AMEC Project Number VM00448

**Reference: Mt. Polley Mine Tailings Facility
Optimization Potential – Follow Up from Dam Safety Review**

**TSF Potential Optimization Workshop
February 2007**

MOUNT POLLEY MINING CORPORATION	
MOUNT POLLEY MINE	
TAILINGS STORAGE FACILITY MAIN EMBANKMENT TYPICAL SECTION	
Knight Piésold	TRUST AGREEMENT No. 1 Rev. No. 107 VK101-1/10 105-1100 A
	FIGURE 2

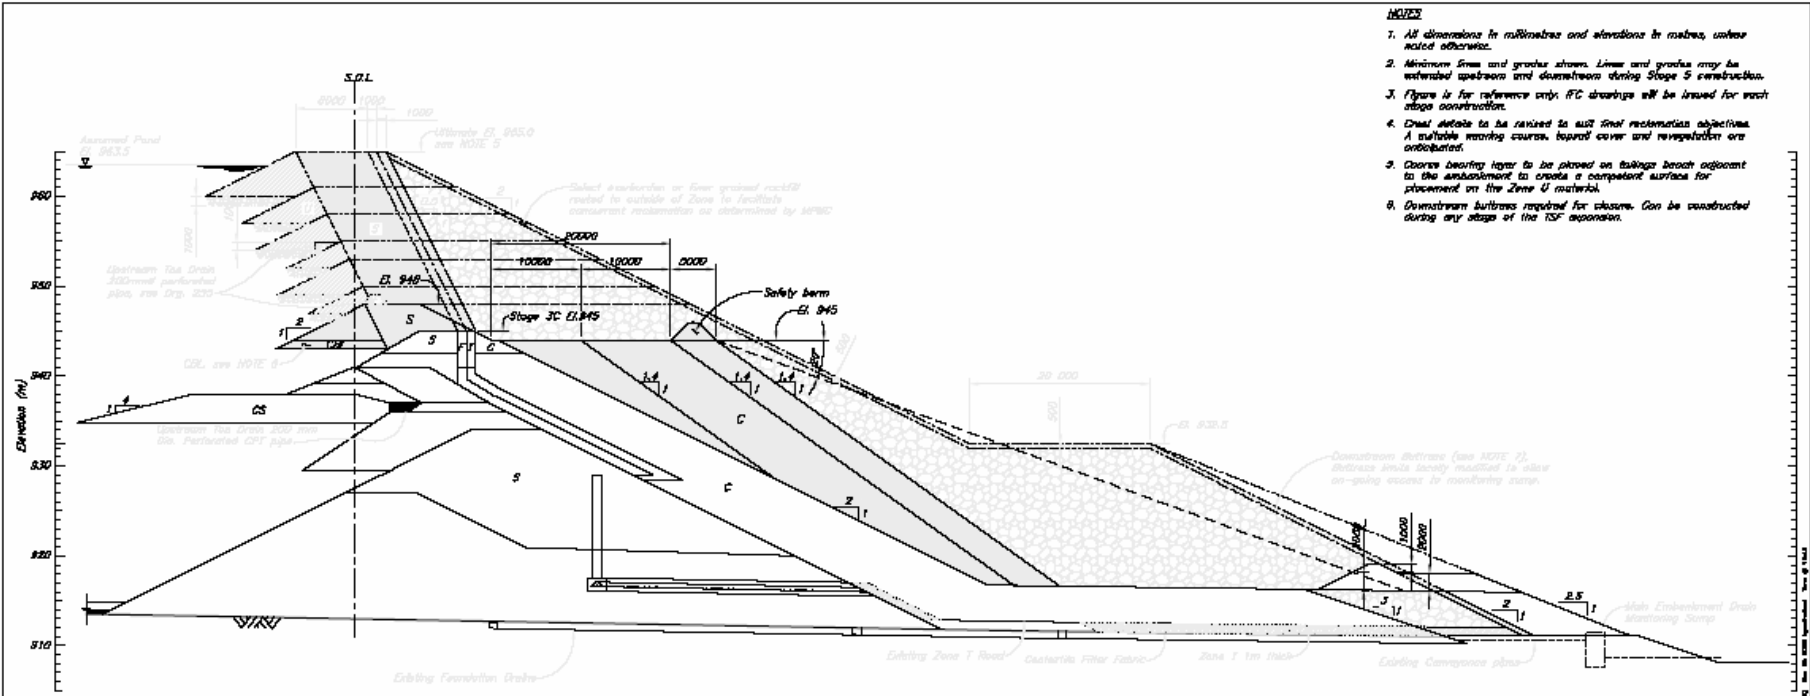
From our review we consider that there is a real opportunity to reduce the width of the core zone being stipulated for the raises moving forward. It is common dam engineering practice to narrow the core with height in the dam though there is a minimum thickness for the core (typically a practical construction consideration). The current core width of 8 m is certainly robust. Given the remaining projected height of dam construction to final elevation (assuming that the currently stipulated final elevation is not significantly exceeded), a decrease in core width should be considered for the 2007 raise and each raise thereafter. An acceptable rule of thumb is to have the core width be a minimum of 30% of the maximum head on the core; for example 20 metres of head corresponds to a 6 metre minimum requirement. The core could be further narrowed as the dam is raised in future, down to a practical minimum width of 3 m to 4 m.

Per the 2006 DSR report, it remains unclear to us why a buttressing berm has been specified for the closure geometry of the TSF. Provided that the foundation parameters are consistent with the glacial till reported in the documents to date, there should not be a foundation concern with the existing Main Embankment Dam geometry. The foundation strength parameters indicated in design documentation for the TSF to date and the current planned geometry without a berm would result in adequate stability conditions for operations and the closure condition.

The only uncertainty is the nature of the foundation soils regarding potential presheared planes of weakness. This issue was raised during the DSR but had not been noted in previous design documentation. If there is no such concern, as above, then there would appear to be no real need for the proposed berm.

Finally, if there is a valid reason for the berm identified the berm material need not necessarily be waste rock from the mine. All that would be required is an equivalent mass and, depending upon placement and geochemical considerations, even tailings may be an acceptable berm construction material.
